Applicant : Wayne A. Loeb et al.
Serial No. : 10/767,045
Filed : January 28, 2004
Page : 25 of 25

POWER AMPLIFIER PROTECTION LOEB ET. AL

Appl. No.: 10/767,045
Amendment in Reply to Office action of July 7, 2006
Annotated Sheet Showing Change(s)

SHEET 3/9

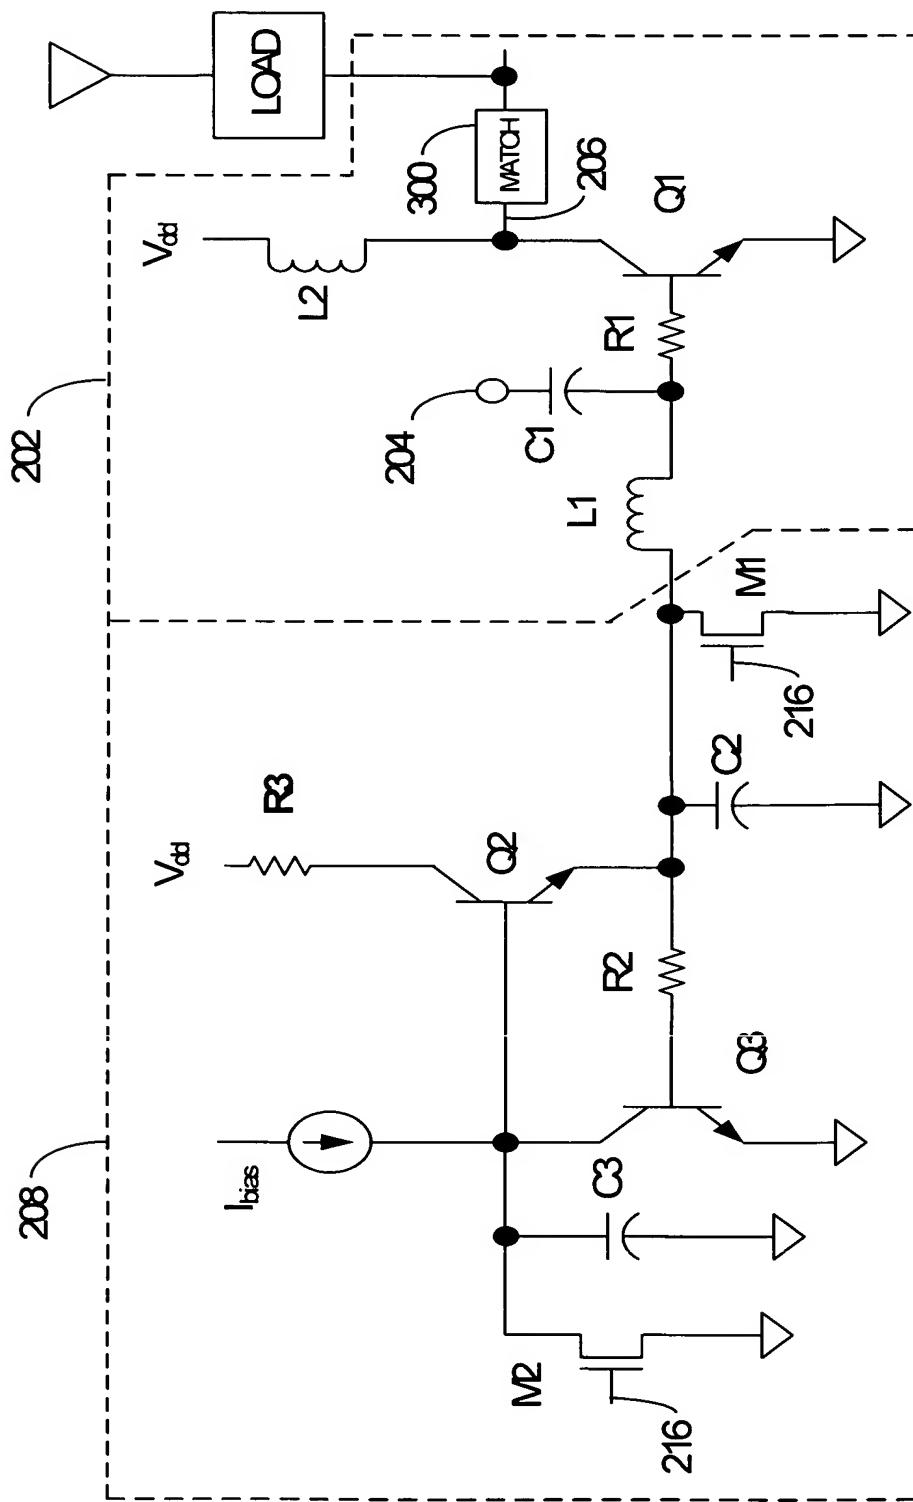
The Examiner objected to the drawings, noting that the resistor connected between the collector of transistor Q₂ and the power source V_{DD} in the biasing network of Fig. 3 was not labeled. Applicants have amended Fig. 3 to label the resistor as R3. Accordingly, Applicants believe that the drawings as presented are in compliance with 37 CFR 1.83 and respectfully request withdrawal of the objection.
